GROUP Body	MODEL Soul (AM) 2011MY
NUMBER 096	DATE June 2013

TECHNICAL SERVICE BULLETIN

SUBJECT: SERVICE ACTION: HORN ASSEMBLY INSPECTION AND UPGRADE PROCEDURE (SA144)

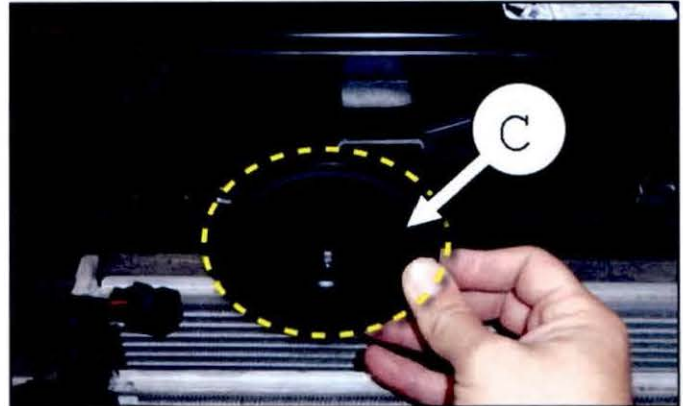
1. Open the hood.
2. Remove the front fascia by referring to the Service Information on KGIS.
3. Locate the horn and remove the harness connector (A) and the bolt (B) securing the horn bracket to the vehicle.

4. Install the replacement horn assembly (C).
